# LYNWOOD HEIGHTS

WATERFORD, CONNECTICUT

ENVIRONMENTAL REVIEW TEAM REPORT  
ON  
LYNWOOD HEIGHTS  
WATERFORD, CONNECTICUT  
MAY, 1974

ENVIRONMENTAL REVIEW TEAM REPORT  
ON  
LYNWOOD HEIGHTS  
WATERFORD, CONNECTICUT

## TOPOGRAPHY

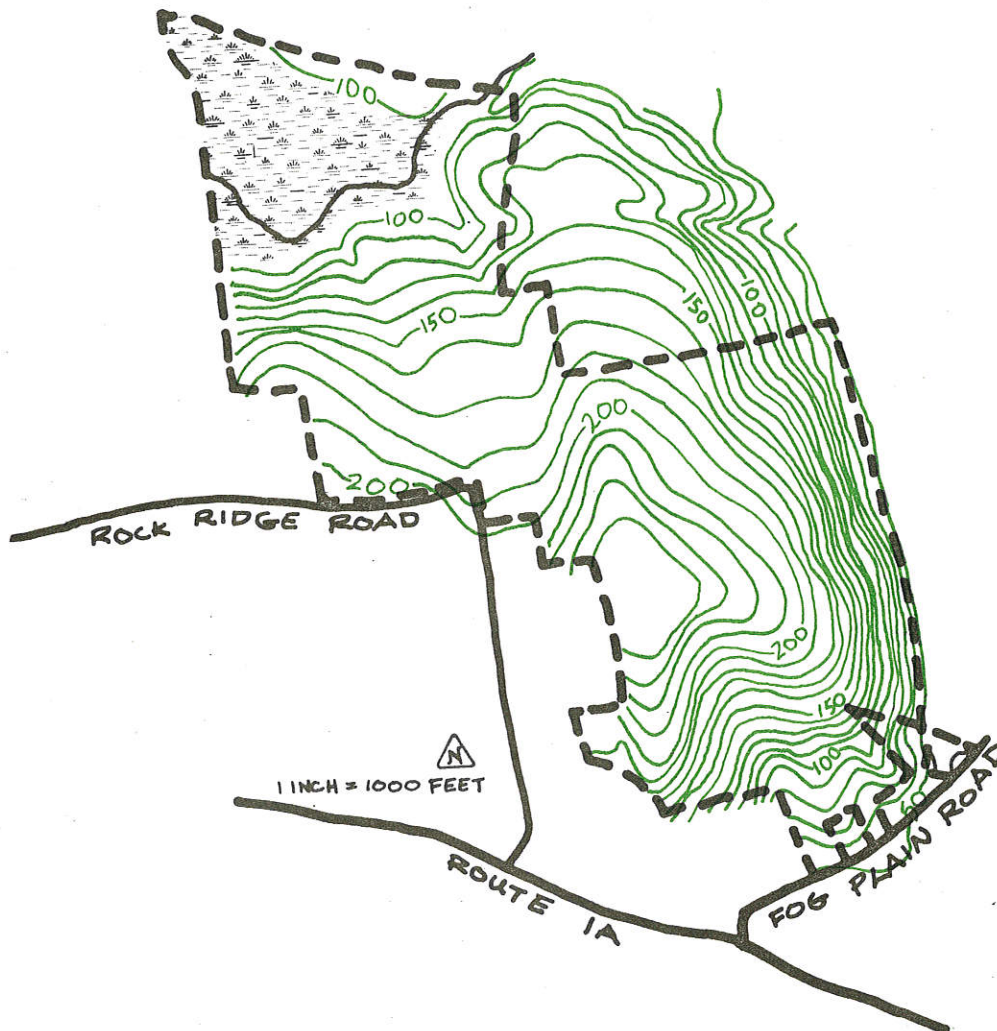
Section I. The land within Section I of the proposed Lynwood Heights Subdivision generally exhibits gentle to moderate slopes with several small areas of steep slopes (see topography map on opposite page). All of this land drains into the extensive wetland to the north. When the Team visited the area, much of the central portion of the area to be developed was very wet, with water covering the surface. The land on the western part of this area is somewhat better drained.

This section is covered by a sandy, bouldery till which has a variable composition and texture. Although the uppermost layers of the ground materials appear to be quite sandy, locally high water tables are present, suggesting that a relatively impermeable layer underlies the surface at a shallow depth. Since the land does not drain a large upslope area, the local high water tables are caused by the retention of ground water and the poor draining characteristics of the underlying ground materials. These materials may be either bedrock or compact till. At several locations bedrock appears to be fairly close to the surface, and local concentrations of boulders are evident. Artificial lowering of the ground water table may be difficult if an impermeable layer does exist at a shallow depth.

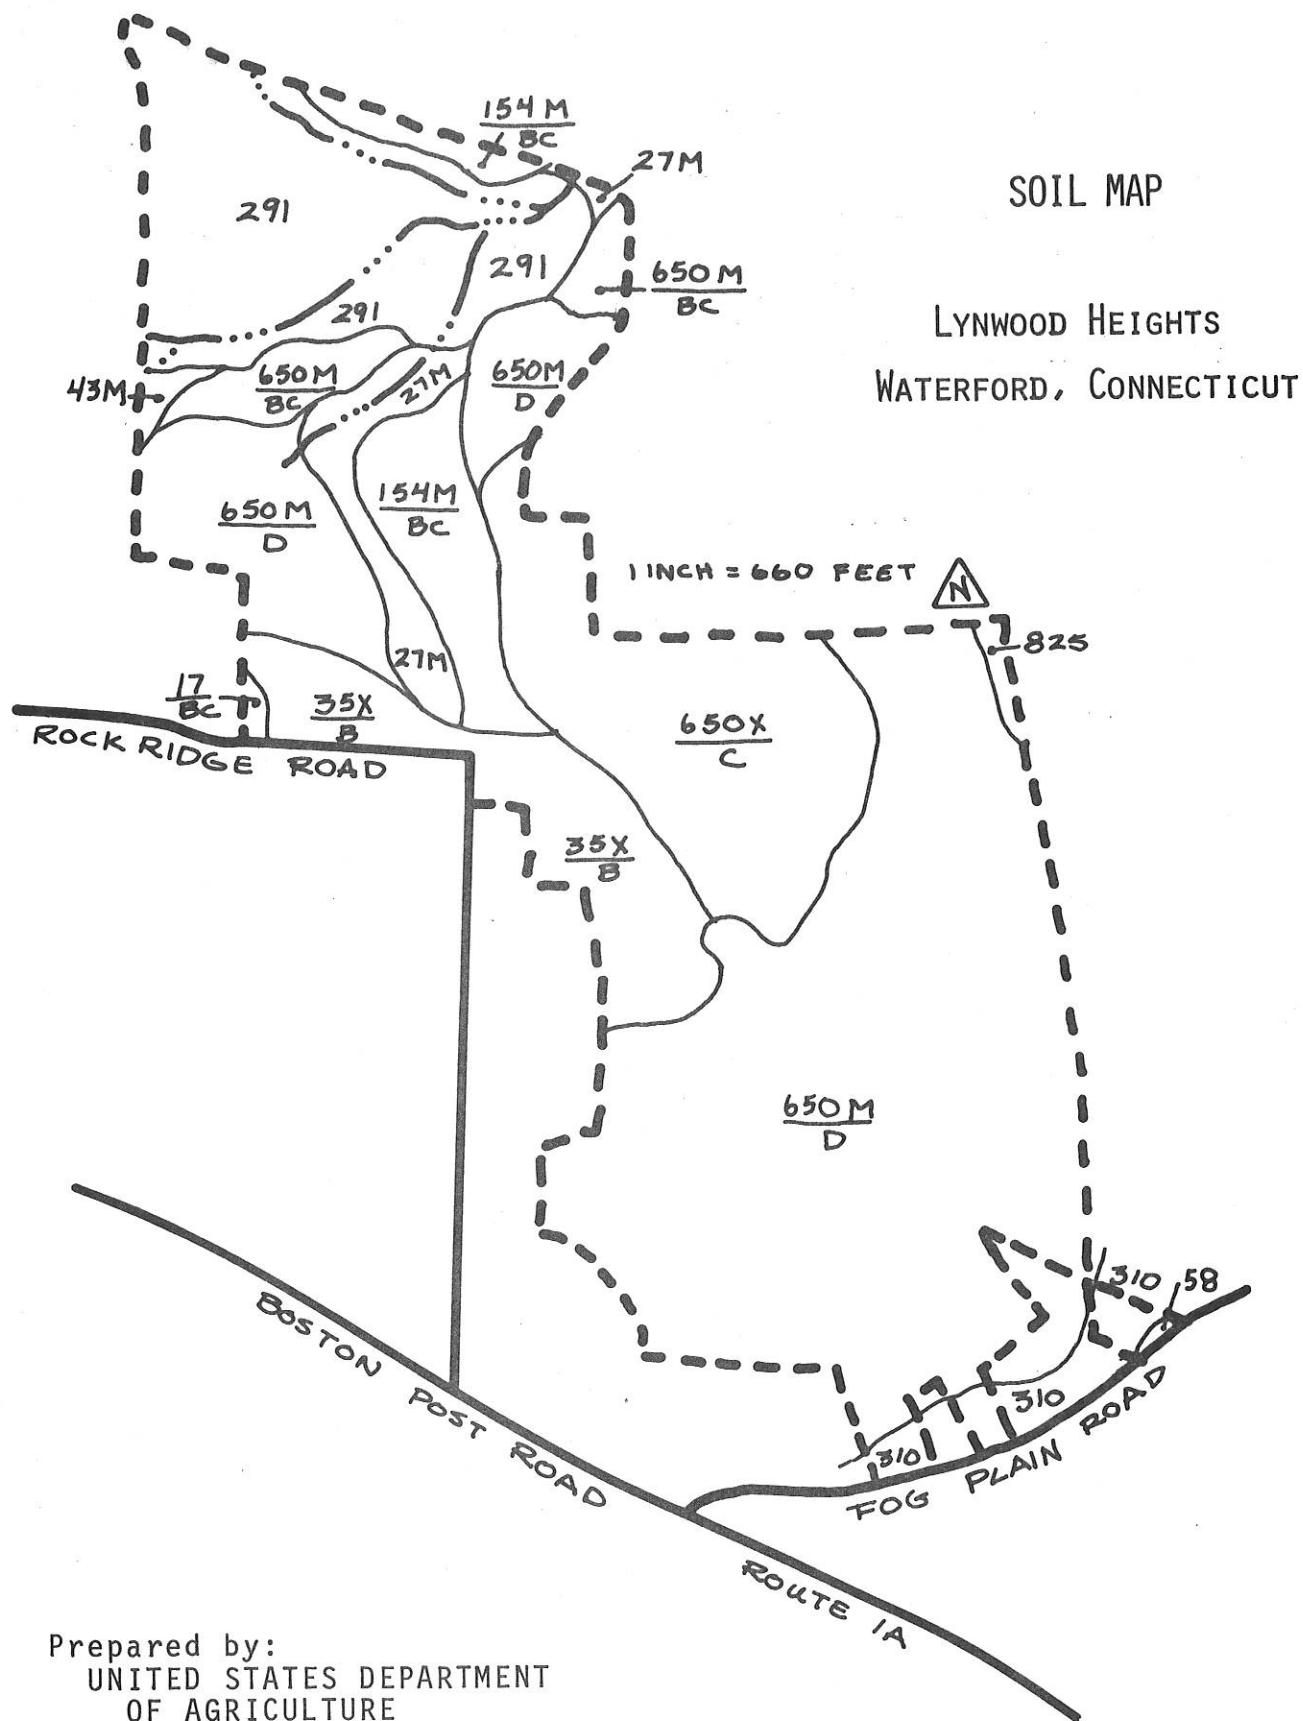
In light of the plans for the area, the potential septic problems over much of the site, and the high scenic quality of Manitock Hill, a lower density development with an emphasis on conservation would be desirable. In addition to enlarging lot sizes, there are several ideas which could be considered.

Open space areas could be increased by connecting the two proposed areas with a wide forested strip. The 27M soil in Section I would be much better suited for this type of open space than for residential development. The man-made ponds could also be maintained and used as a focal point for recreation within the subdivision. Activities such as fishing, ice skating, picnicking, and nature walks could be developed here.
